PLANNING COMMISSION AGENDA
Monday, February 22, 2021 at 6:00 p.m.
Caledonia Village Hall – 5043 Chester Lane

RE: Culver's - Storm Water Management Plan & Site Grading Plan Review

The Village of Caledonia Engineering Department has performed a review of the Site Grading Plan and related plan sheets for the proposed Culver's Restaurant at 4542 Douglas Avenue. The following comments have been provided for the issuance of a building permit. All questions in regard to the comments below shall be directed to Tom Lazcano, Public Works Director.

2020.0264.01
 SHEET
C-2

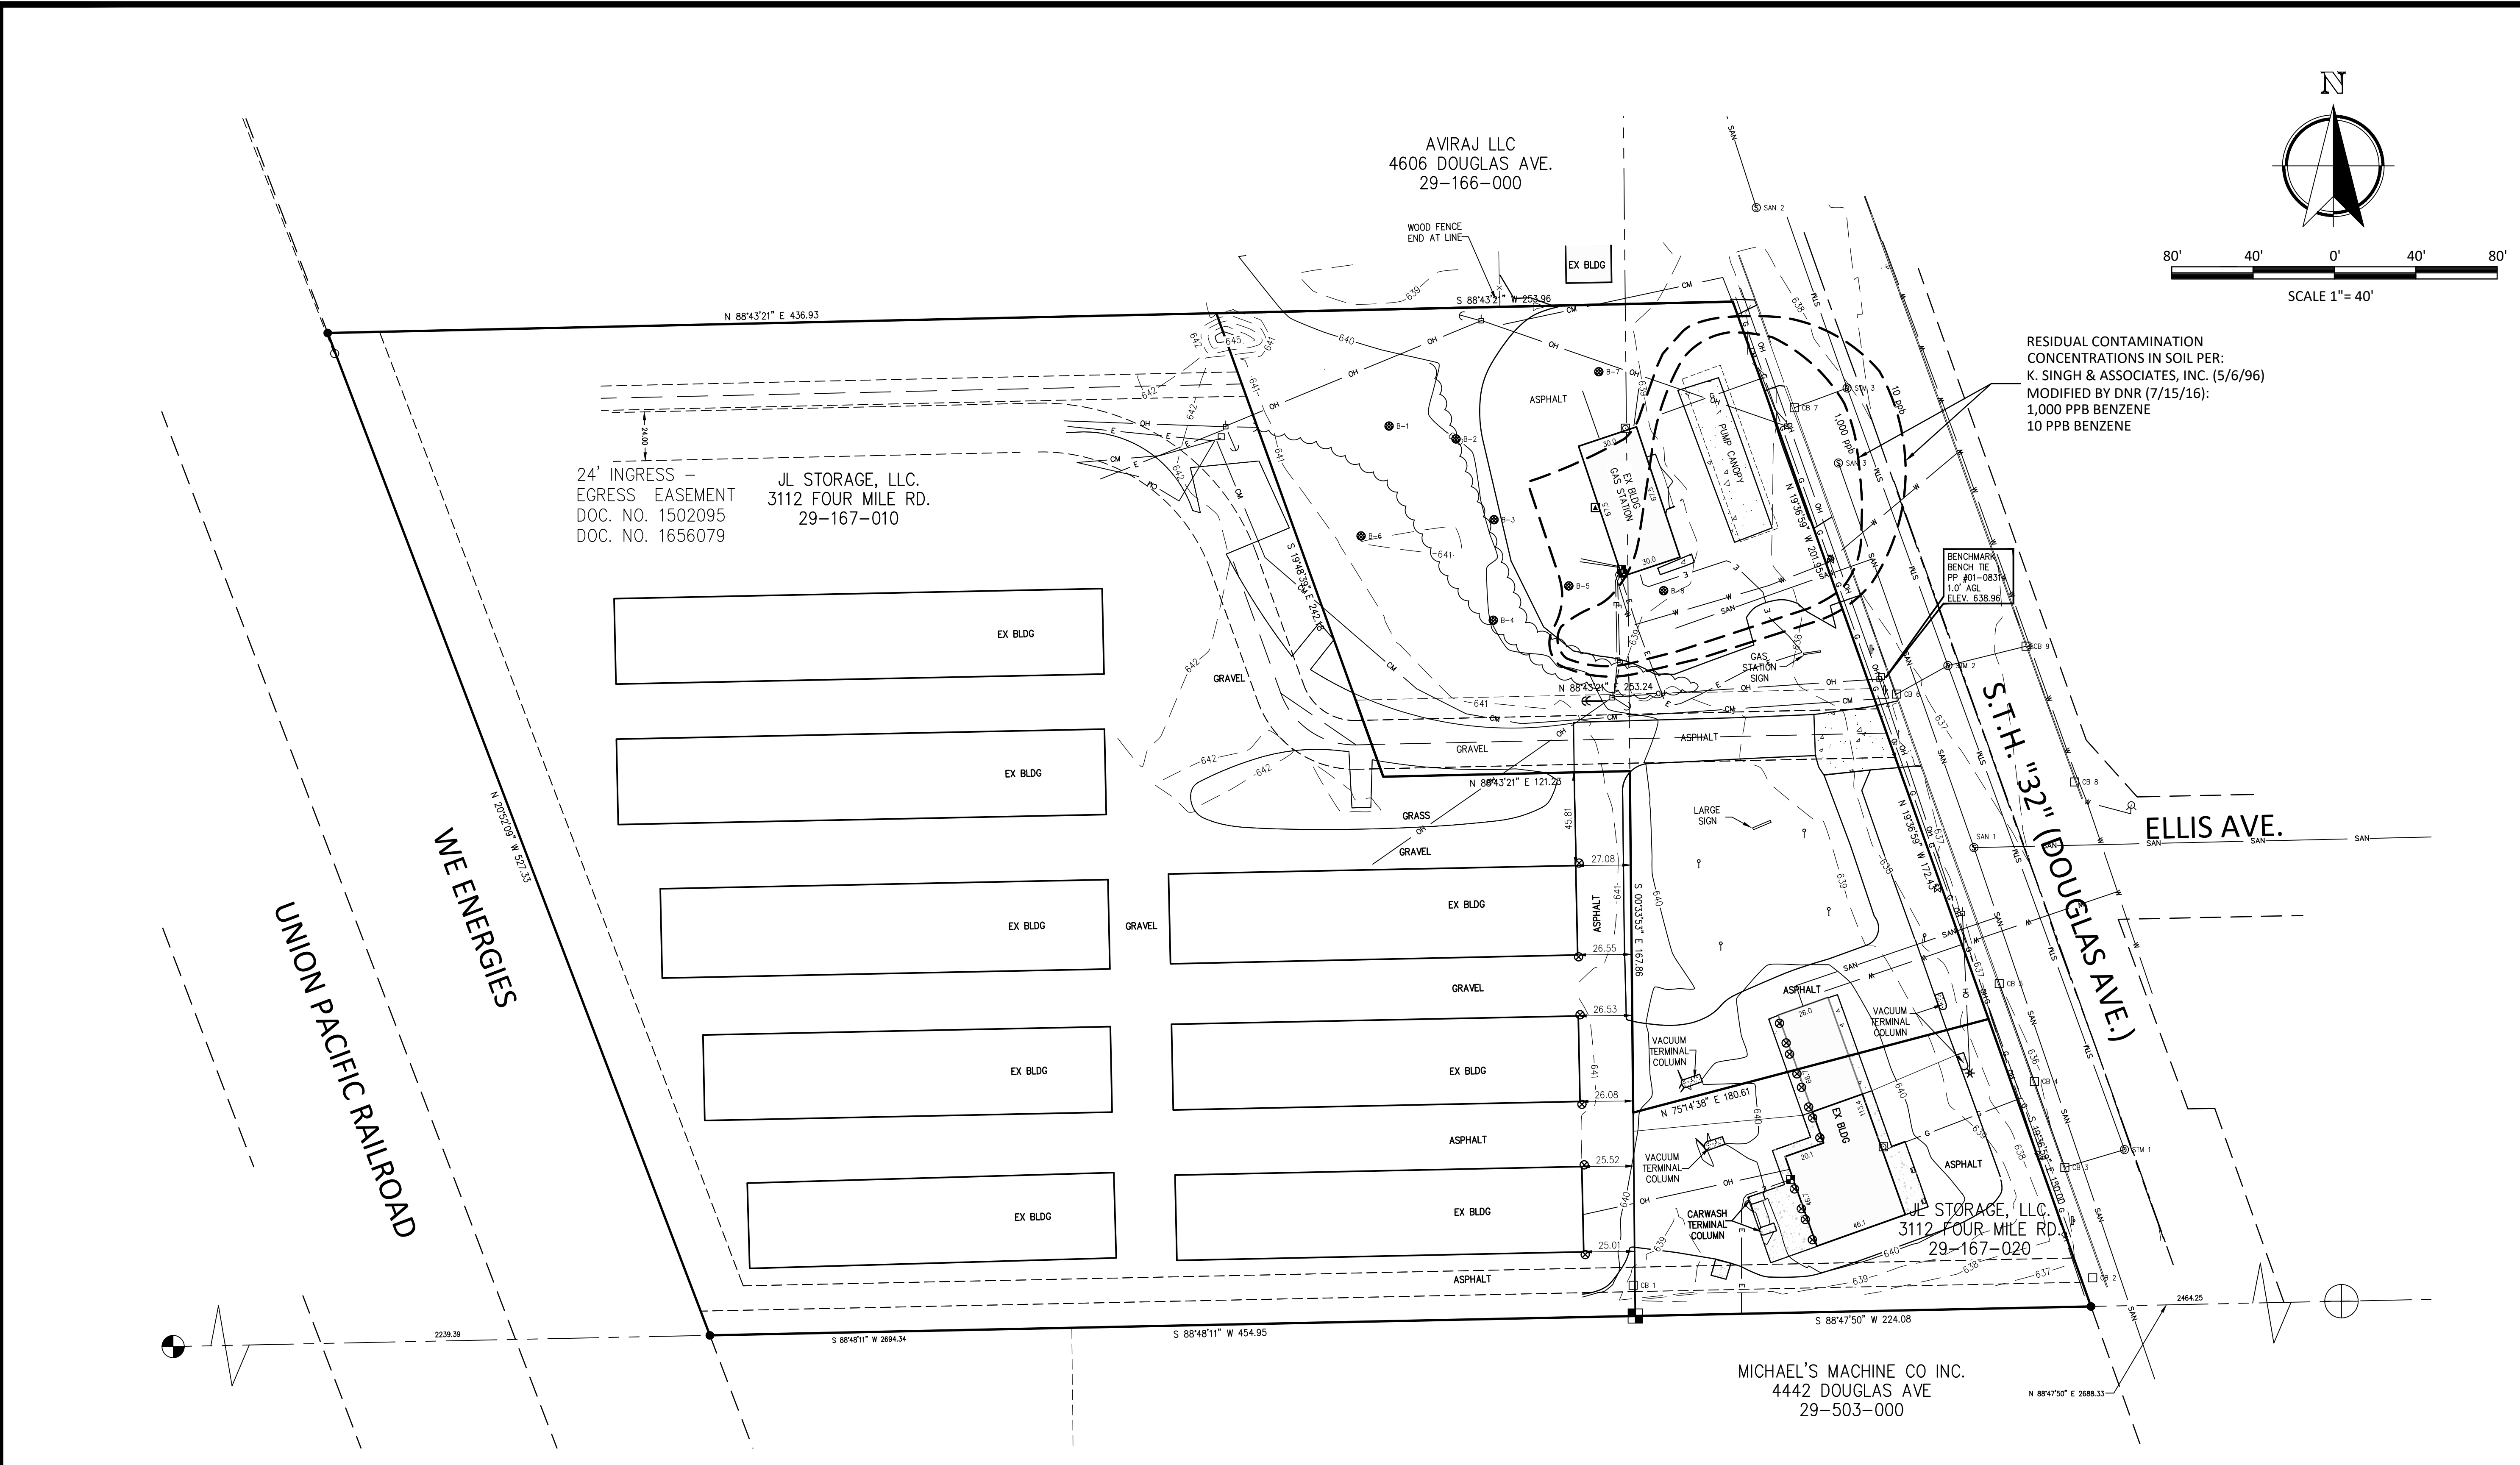
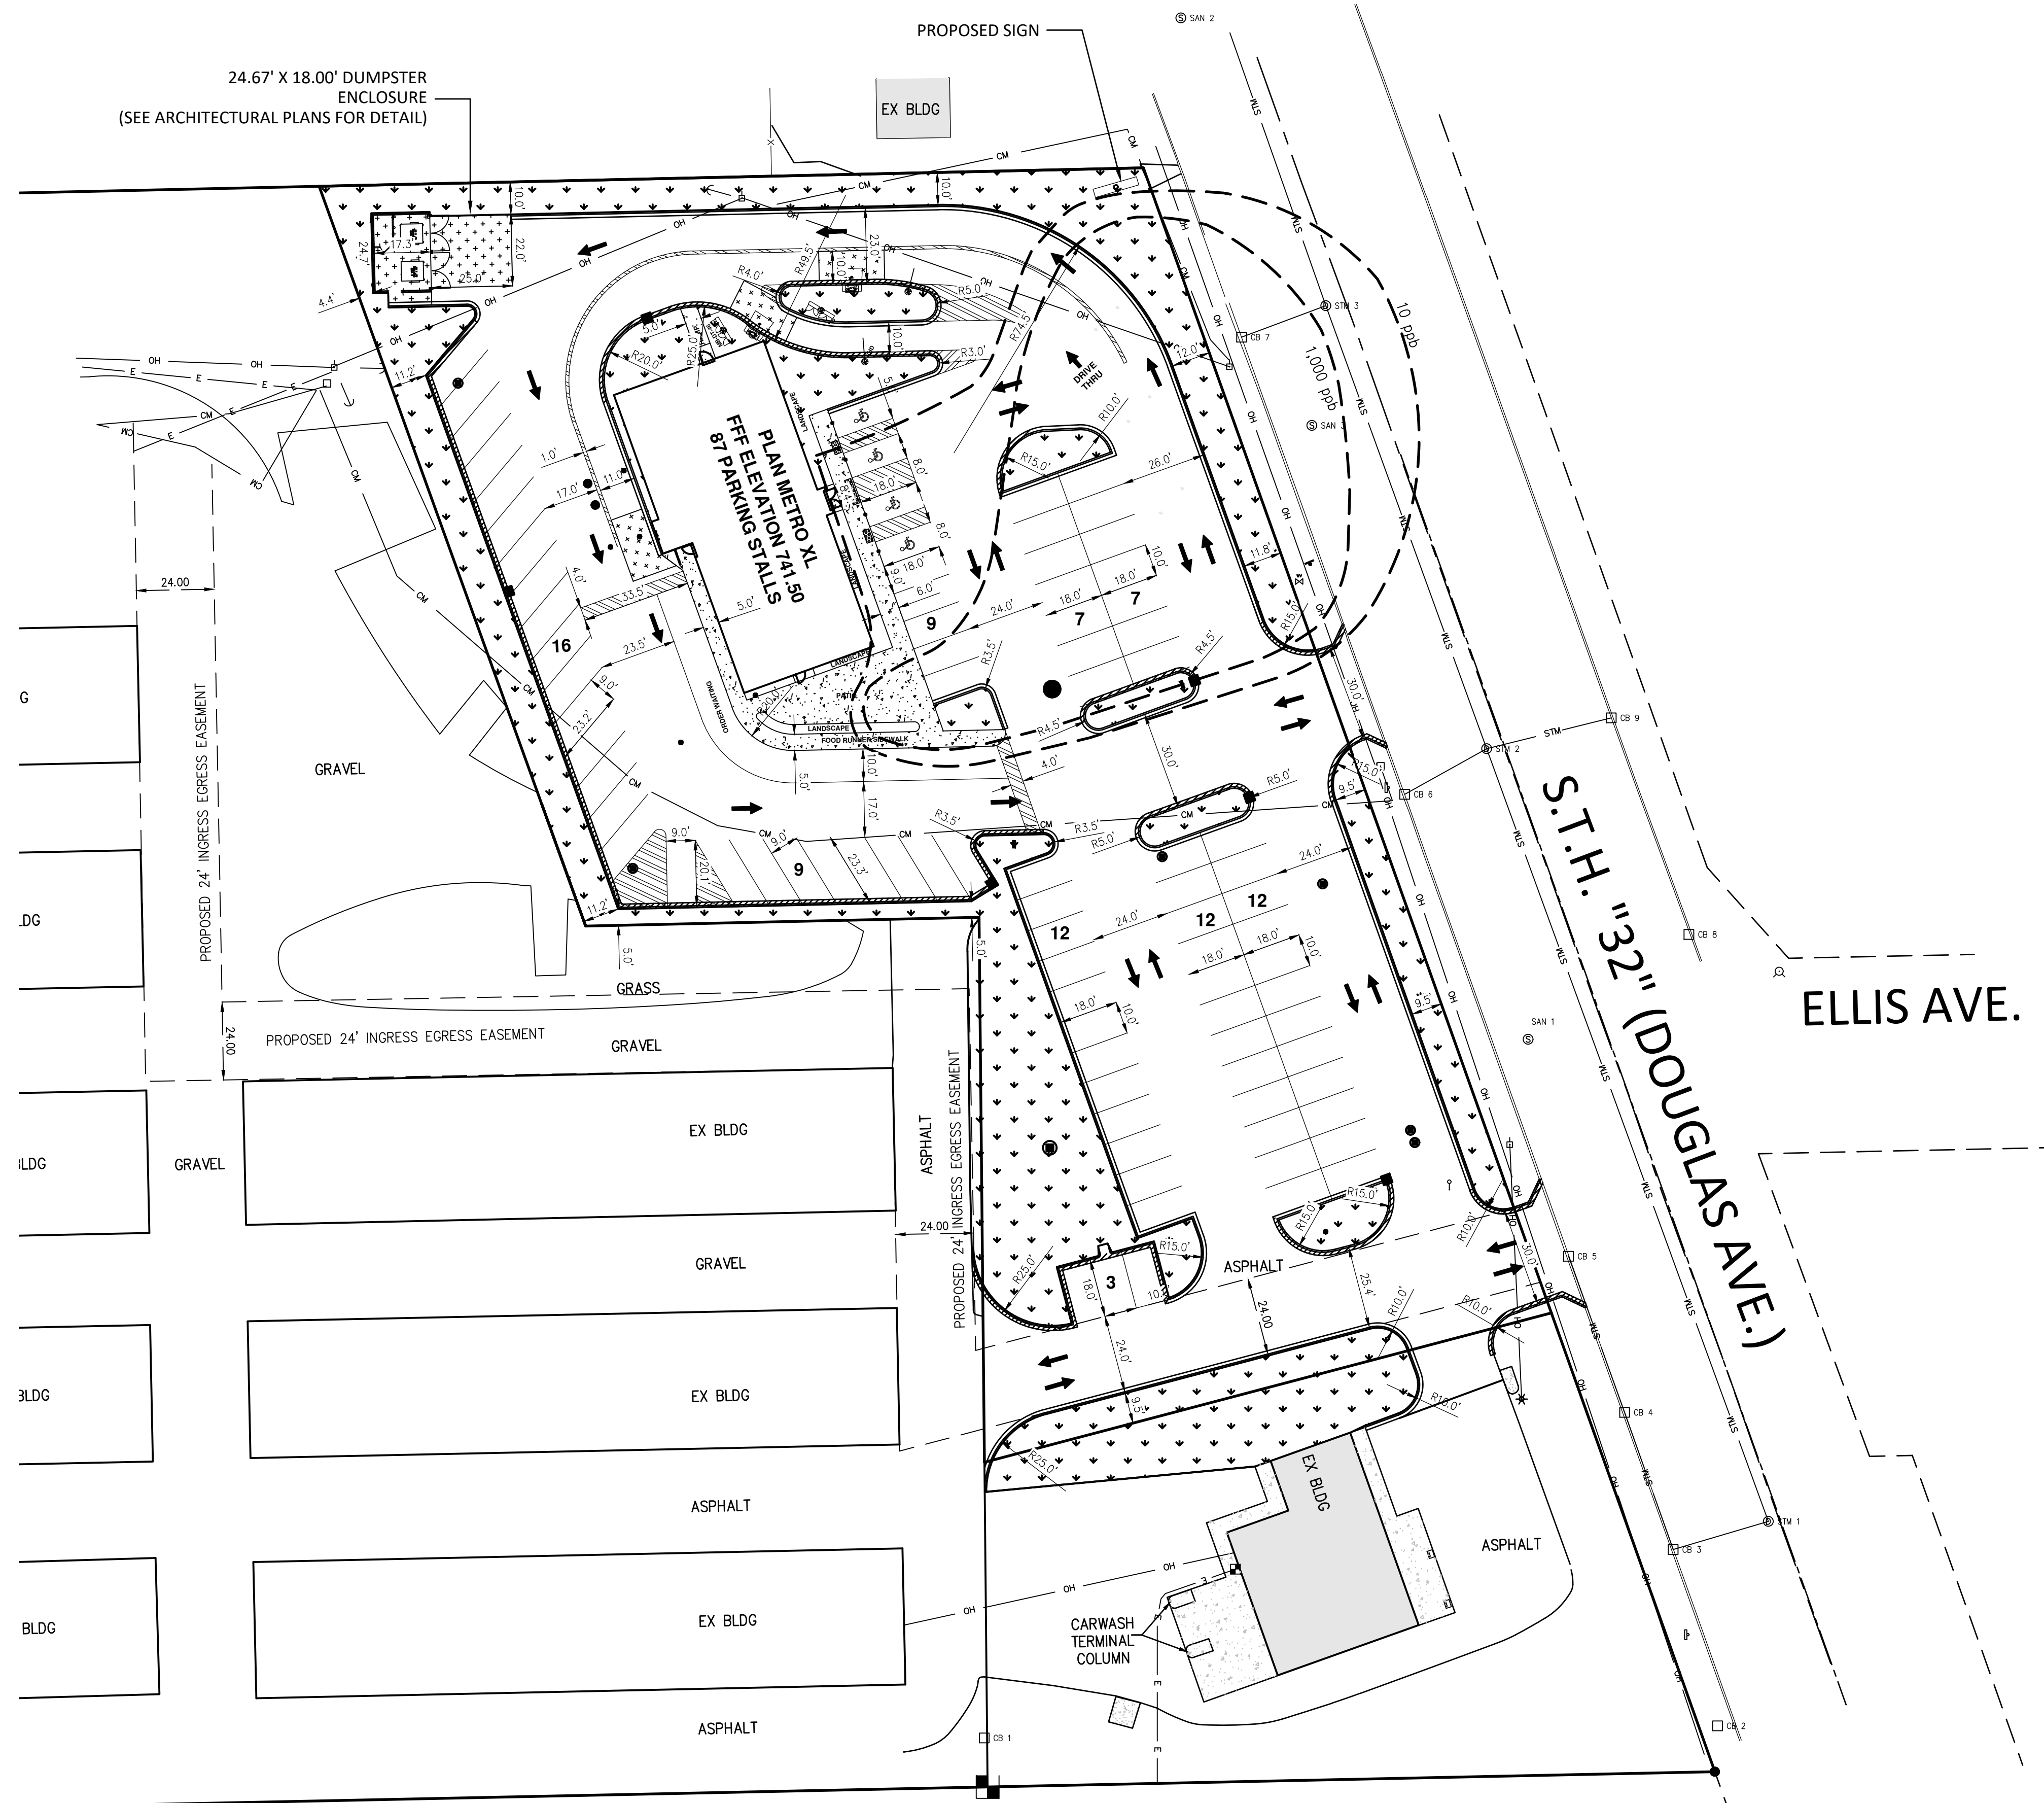
Sheet C-2

2020.0264.01
 SHEET
C-4

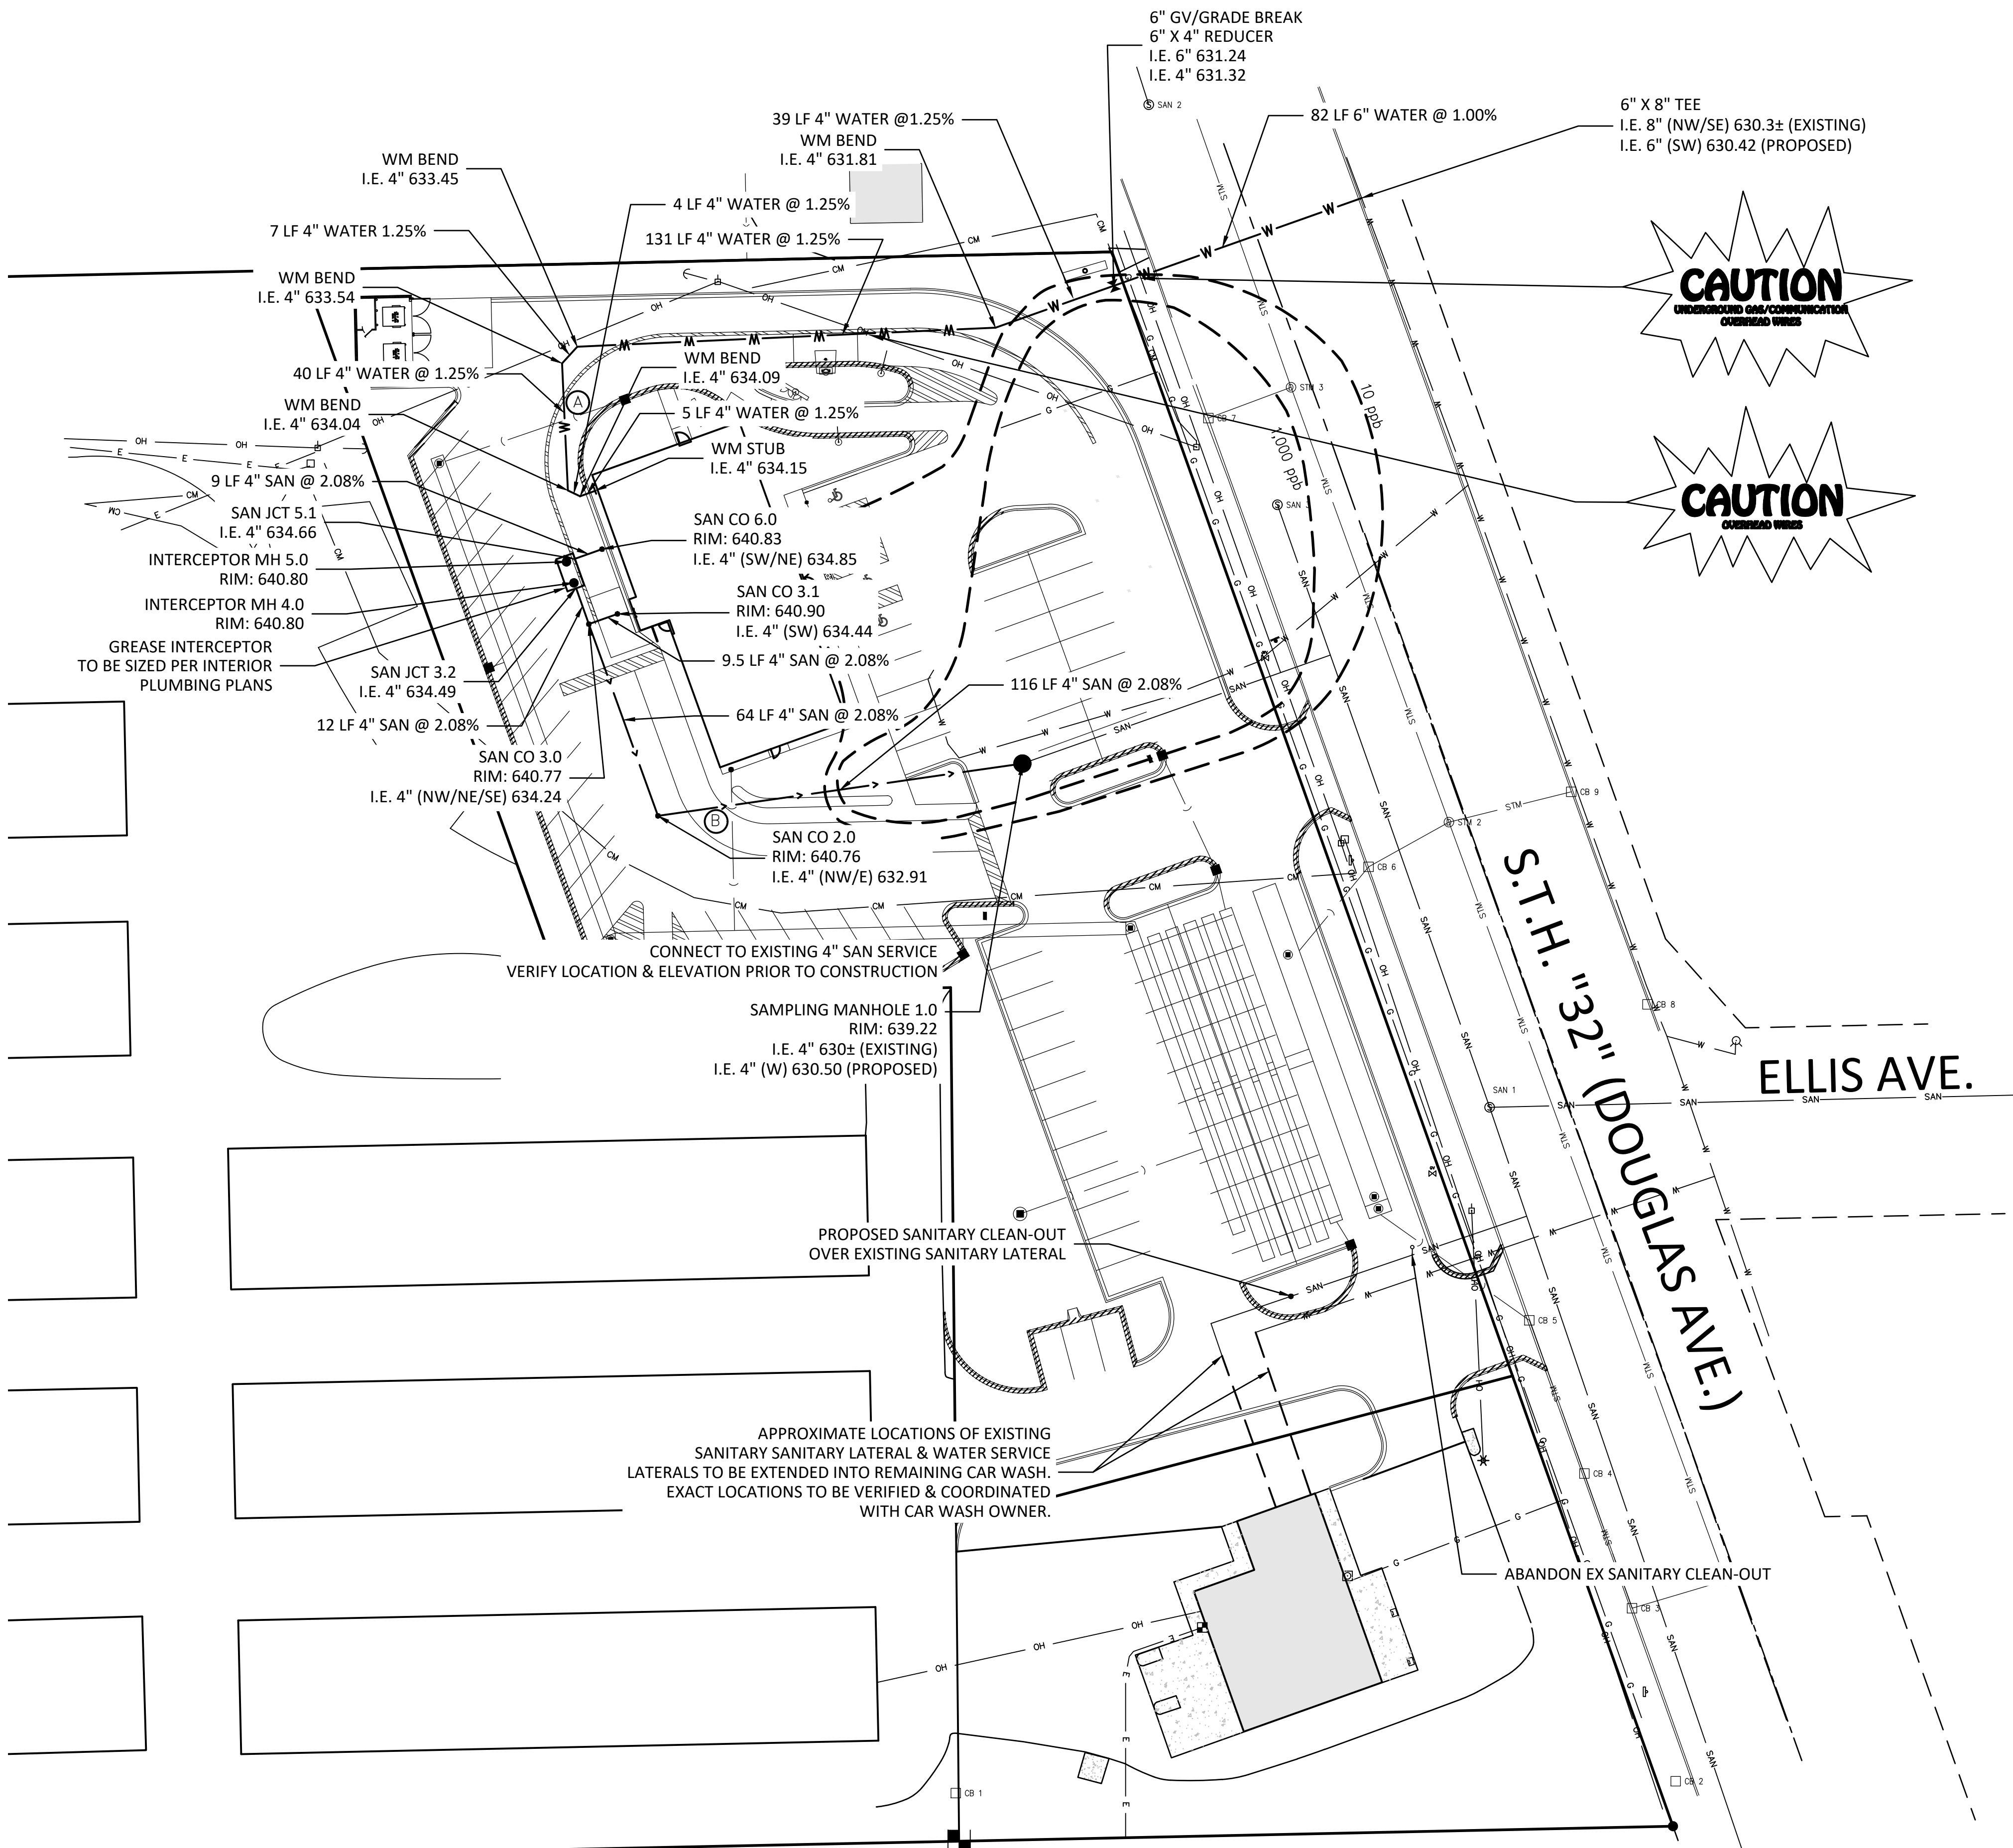
Sheet C-4

1. What does 1' wide cross hatching/separation between the pass thru lane and the order lane (north and west of the building) indicate? Painted marking, curbing? Concrete swale?
2. Is there going to be an ingress/egress easement over the south driveway access to access the Longo storage site? If so, show easements.
